room2 Homotel: Manchester Piccadilly

Design and Access Statement Addendum (Updated) – July 2024

Document Title	HMP-BA-XX-XX-TRP-A-0004 - Design and Access Statement Addendum (Updated)
Company	Bennetts Associates
Revision	P04
Date	9 th July 2024
Details	Design And Access Statement Addendum updated to address Case Officer comments issued on 13 th June 2024.
Document Number	HMP-BA-XX-XX-TRP-A-0004
Address	Bennetts Associates 38-42 Mosley Street Manchester M2 3AZ

Revised proposals retaining the original cill heights, including revised ventilation proposals and more detail to the bin store access

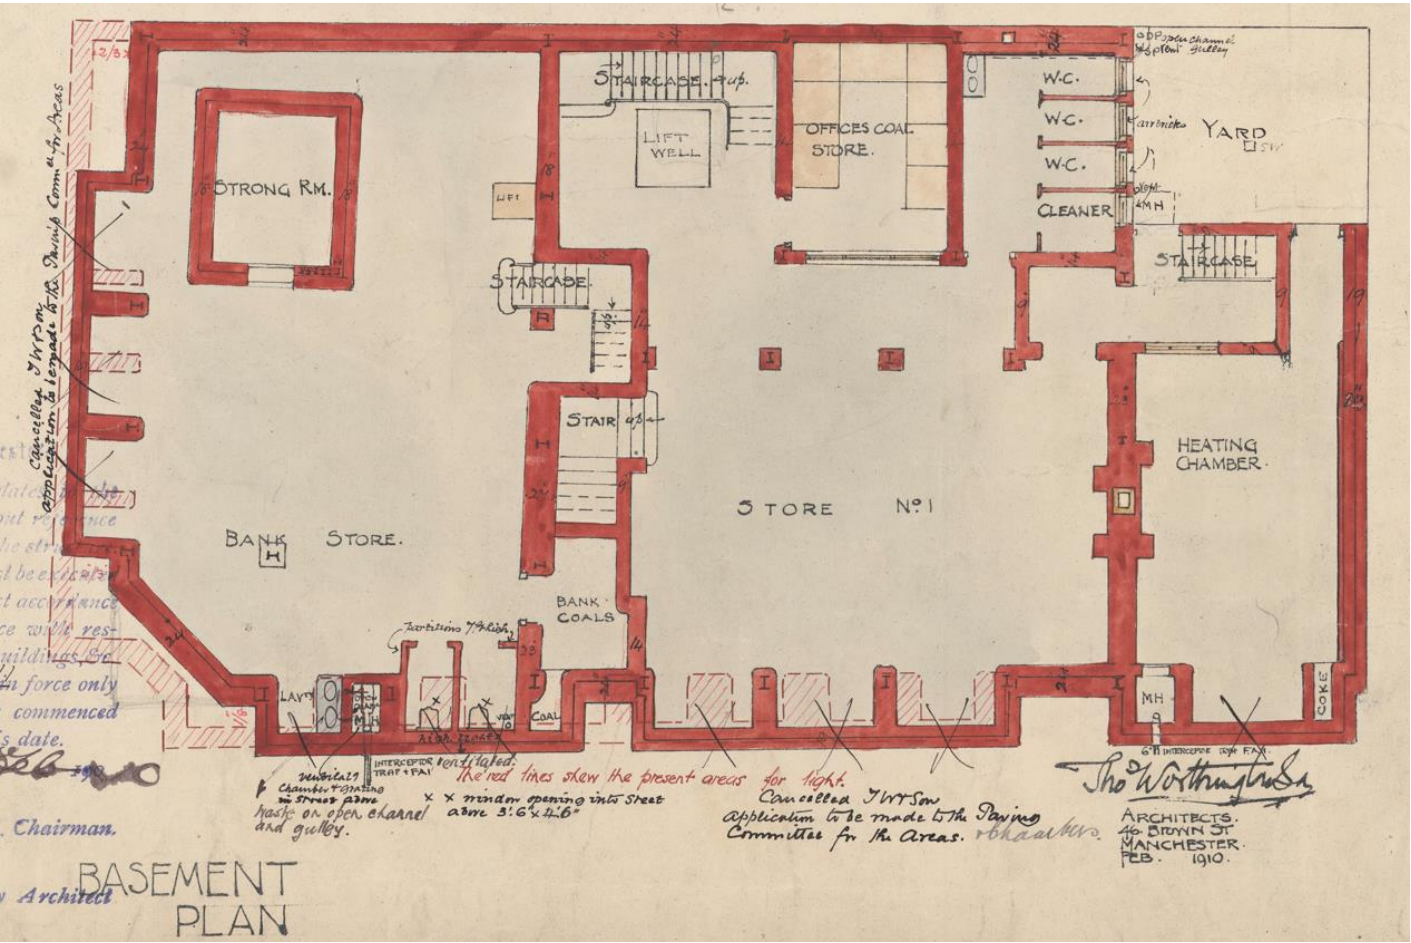
Original MCC Comment: We are not convinced of the need for this and consider that these should be retained as existing – Noting the Heritage Statement which says that the lowering of cills has the potential to affect historic fabric not previously affected by 20th century alterations to this façade. The adverse impact is balanced against the reintroduction of traditional timber sashes to four of the window openings. We do not consider that the required balancing exercise can be looked at as a simple trade off in this way.

Response / agreement at site meeting on 02.04.24: The lowering of window cills proposed to better connect the internal public spaces on the ground floor with the street was reviewed. Following discussion, it was agreed that the existing cill heights should be retained. The application drawings will be updated to reflect these changes.

Basement Level Plan – Plant equipment layout with basement demolitions overlaid

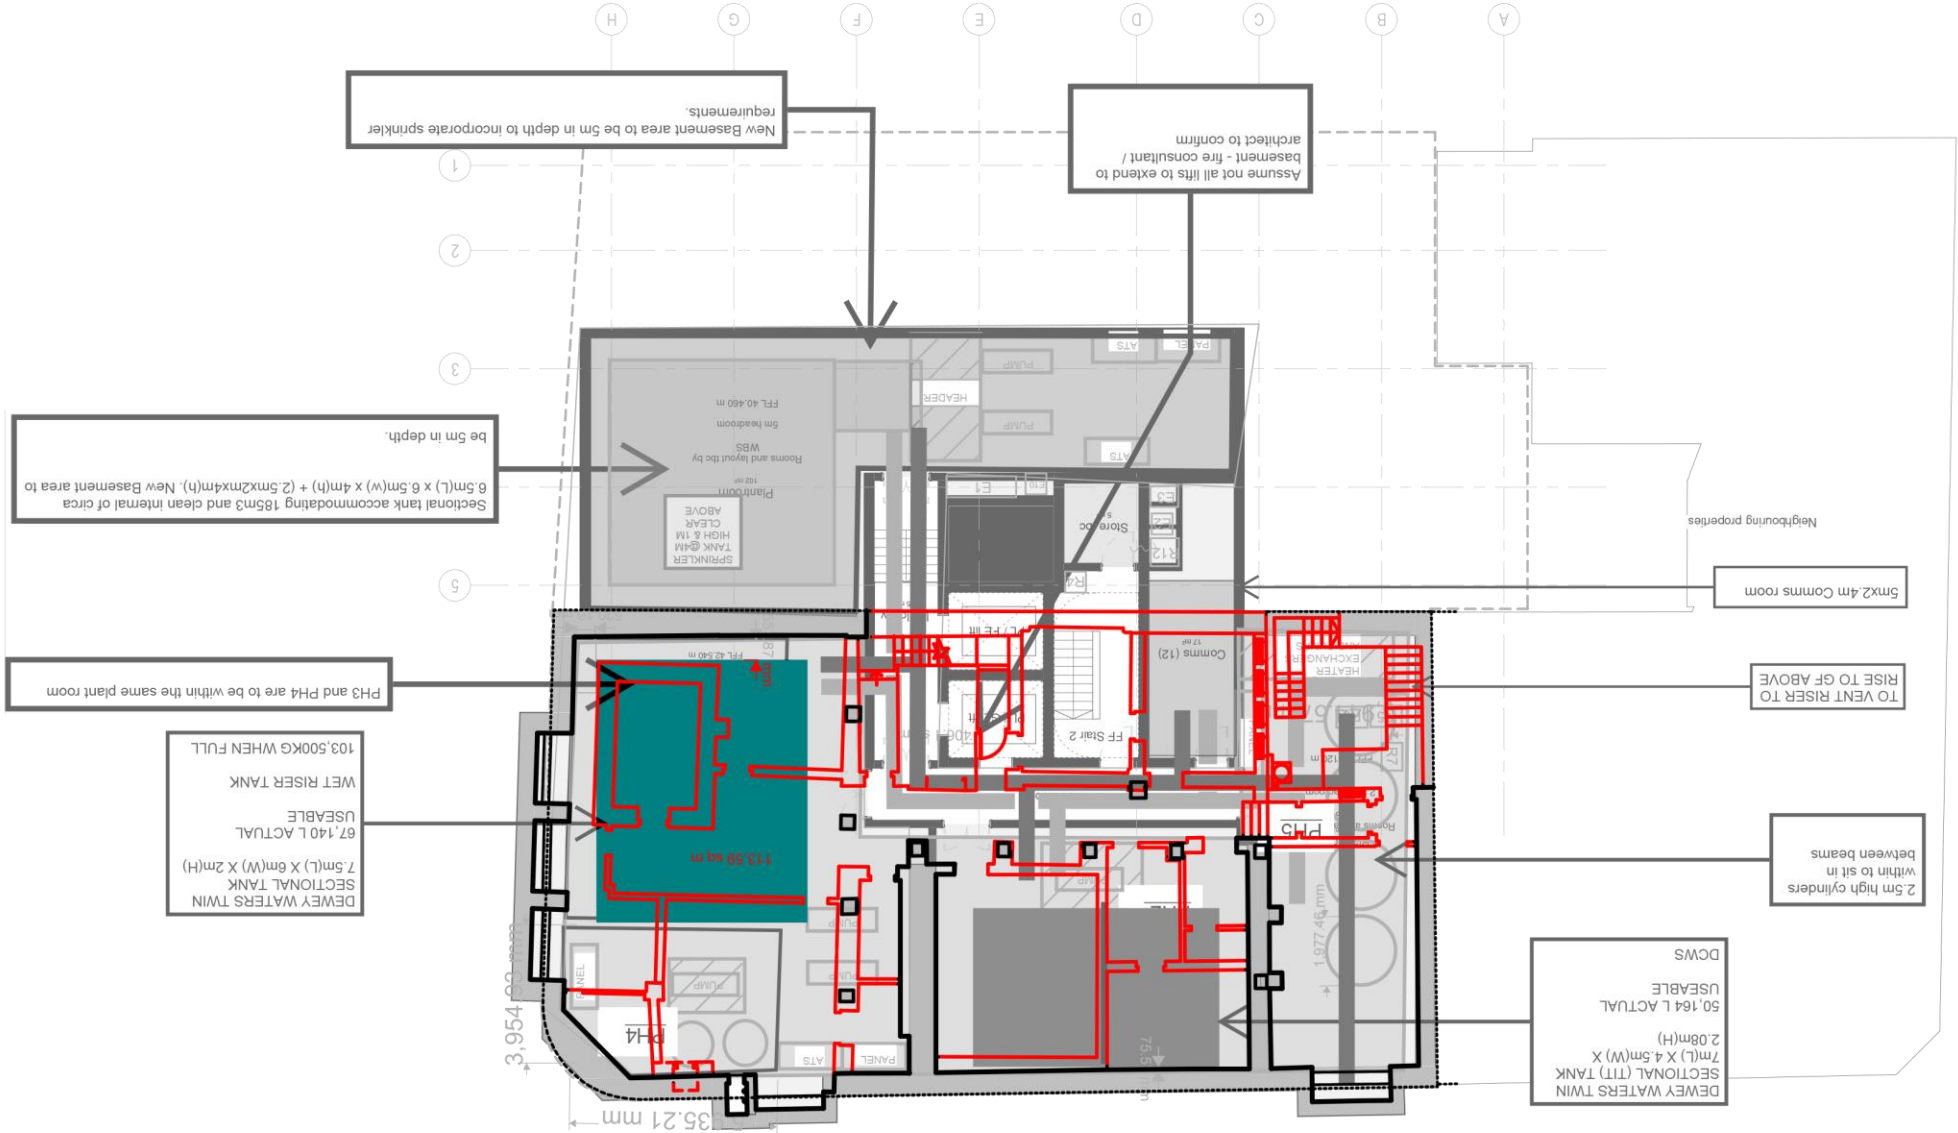
Original MCC Comment: Noting the Heritage Statement. the proposal will further diminish the legibility of the original layout and further restrict an appreciation of the original function of the space and the justification for this is not clear.

Response / agreement at site meeting on 02.04.24: The opening up of the basement floor is required in order to accommodate plant and machinery to support the building above and minimise new basement dig. The plans below show that the basement floor has been much altered from the original layout giving little legibility of its previous layout. The drawings on the following page demonstrates the reasoning which has informed the demolition of the original strong room.

Removal of the Strong Room is required to make room for a substantial new sprinkler tank in the basement and reduce the need for new basement space.

Revised Proposal with raised cills and louvres integrated into the rusticated stone base at street level where the original pavement lights were.

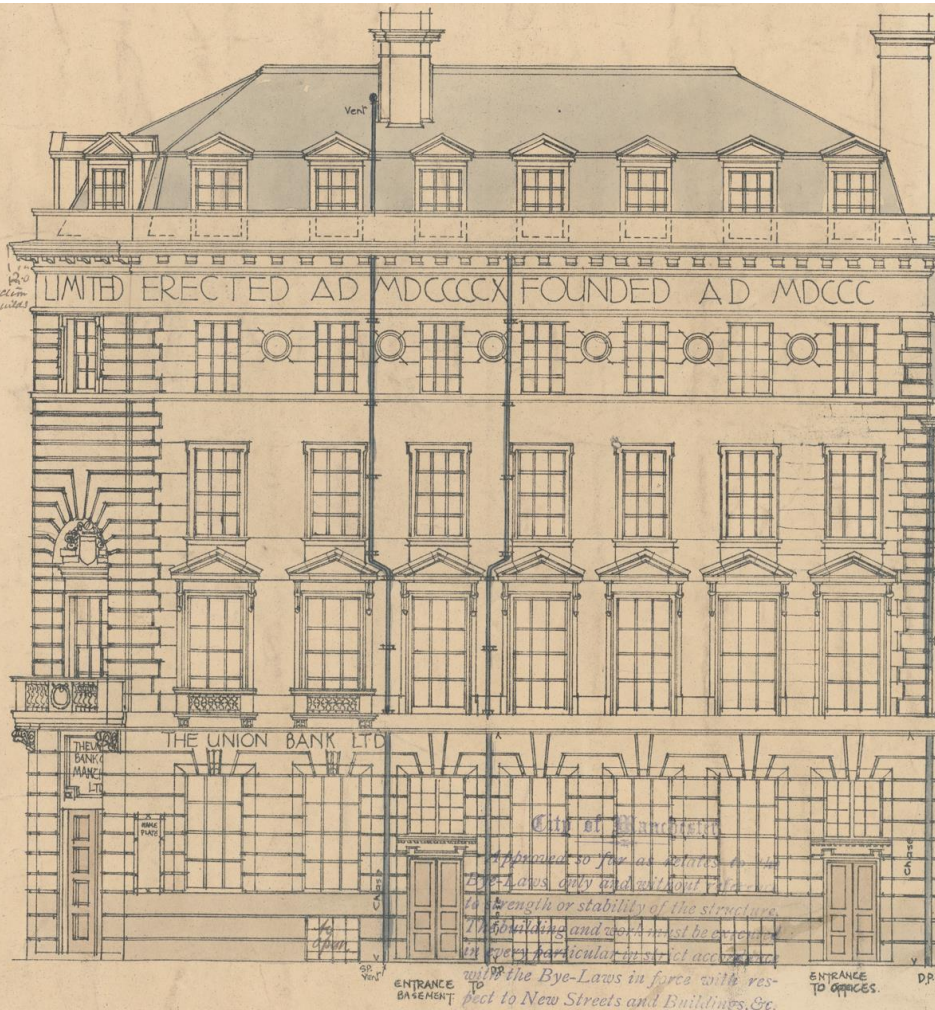
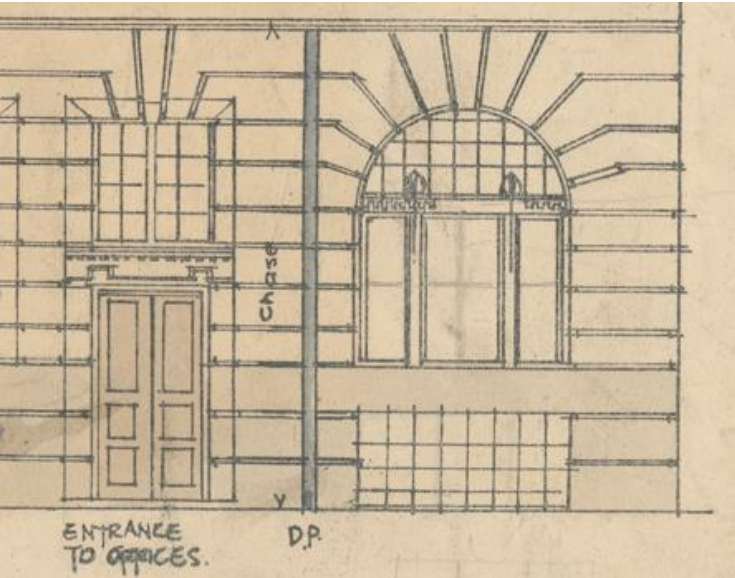
Original MCC Comment: Our preference in terms of architectural quality and impacts on historic fabric is not to have any louvres within the main ground floor windows and we need to discuss the need for these and options on site.

Response / agreement at site meeting on 02.04.24: We have revised our proposals and looked to minimise the amount of louvre proposed in the façade. The proposals presented on site have been developed to consider alternative position, at street level where original pavement lights were located.

Proposals have been revised to reinstate openings in the façade to the basement in order to provide basement smoke extract. This requires the removal of non-original masonry at street level and providing a series of louvred panels set on top of fair-faced stone.

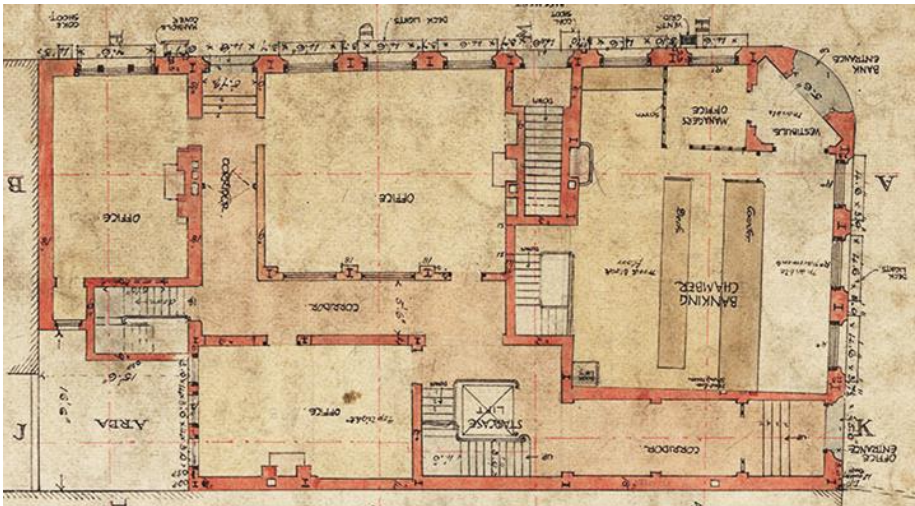
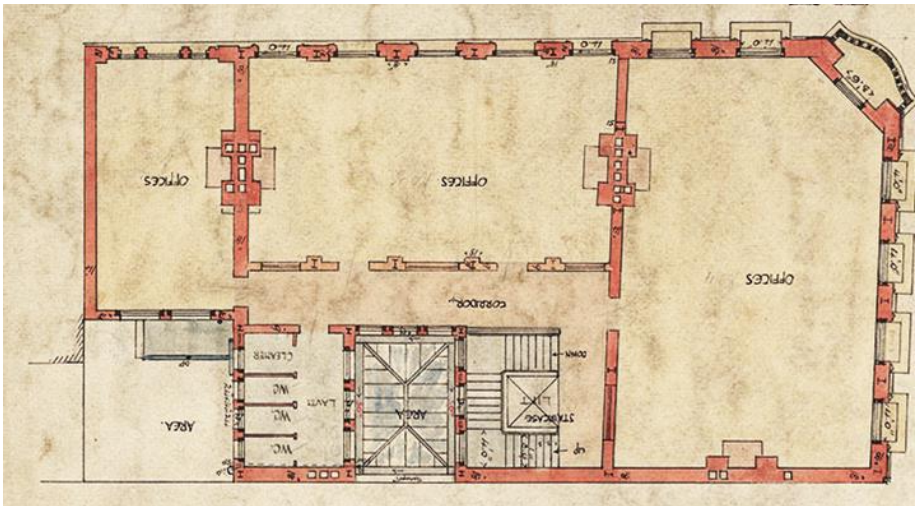
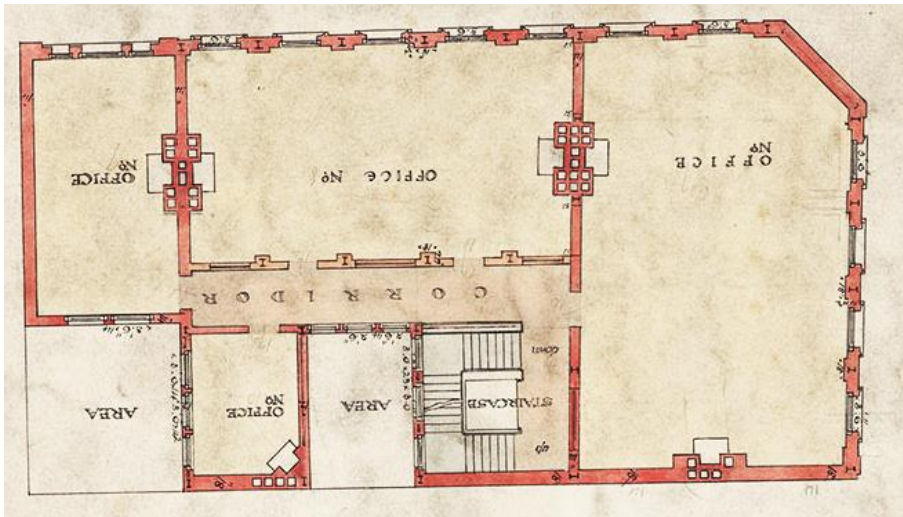
Original MCC Comment: It is considered that this should be more open plan. The subdivision is ill considered and offset from the structural grid and needs to be reconsidered.

Response / agreement at site meeting on 02.04.24: As illustrated on the proposed plans, subdivision on the first floor is kept to a minimum, this floor contains meeting rooms and a net-zero museum and will be publicly accessible. Room subdivisions and bathrooms on floors 2-5 will be reviewed to better align with existing features with typical details for interface between fit-out and historic fabric.

Ground floor demolition plans comparison showing proposed retention of more existing fabric to improve legibility of the original banking hall.

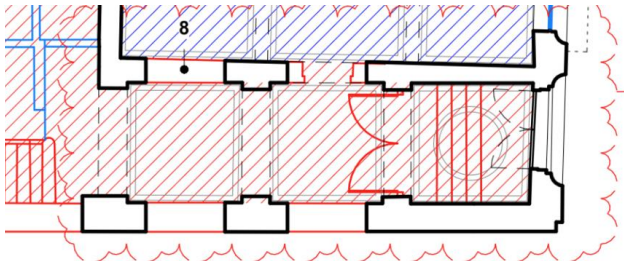
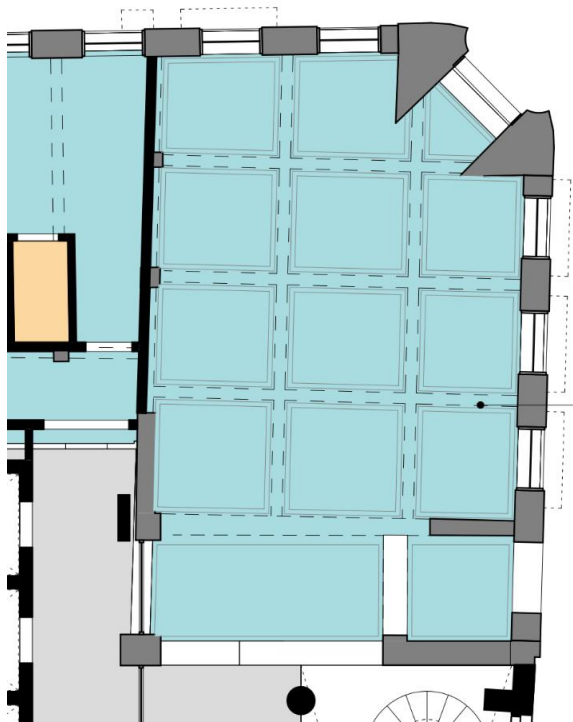
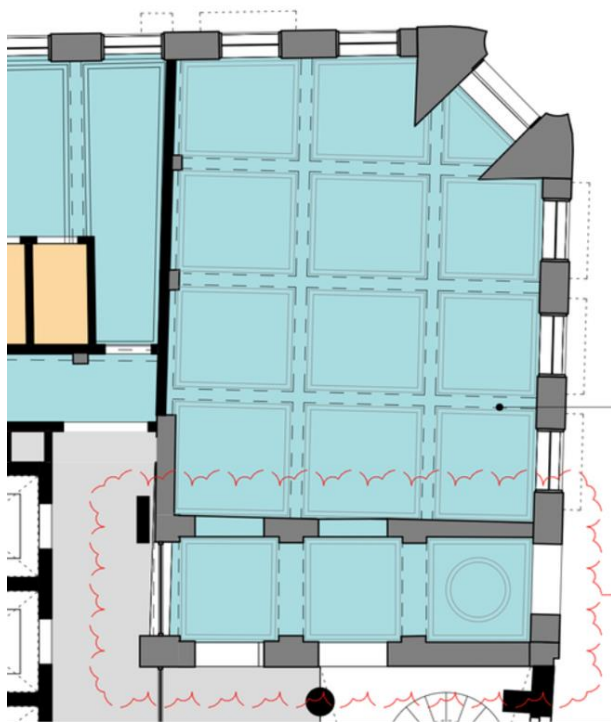
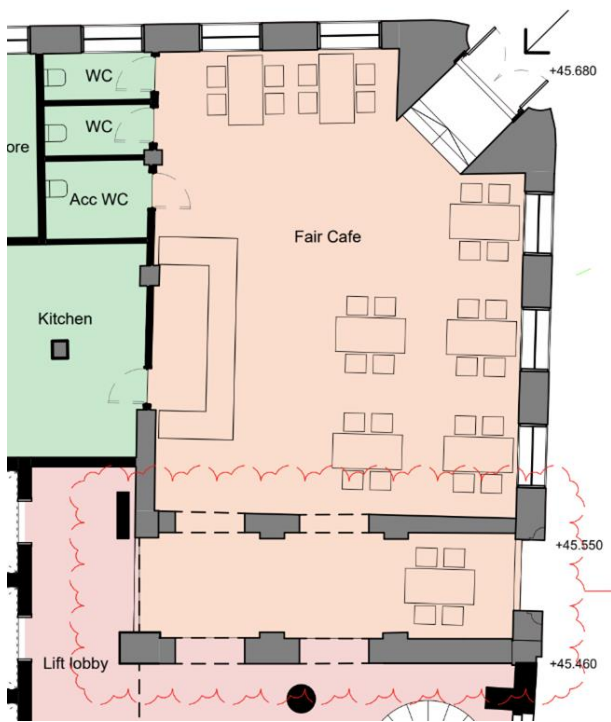
Original MCC Comment: Requires further justification

Response / agreement at site meeting on 02.04.24: These areas were reviewed on site. Agreement to review proposals and seek opportunities to retain greater legibility of original rooms

The plans shown adjacent show the revised extent of retained building fabric to the lobby relative to the proposed ground floor plan and reflected ceiling plan.

Photo survey of existing marble condition in the accessible portion of the original stairwell lobby space

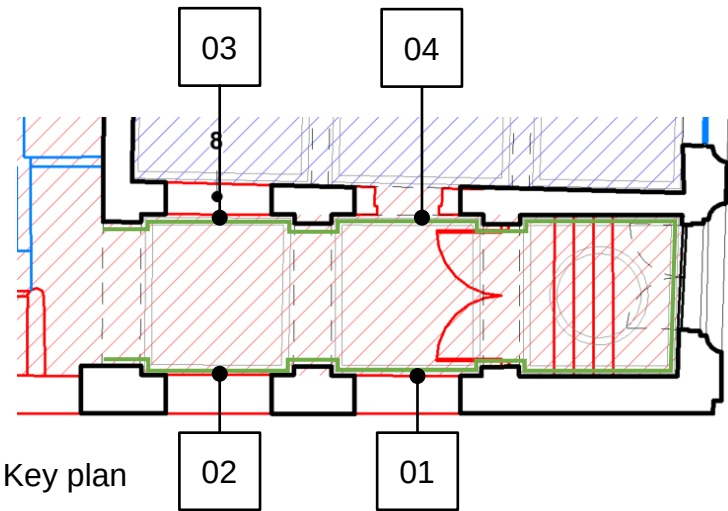
Original MCC Comment: Requires further justification

Response / agreement at site meeting on 02.04.24: These areas were reviewed on site. Agreement to make a proposal for the re-use and / or retention of the marble panels.
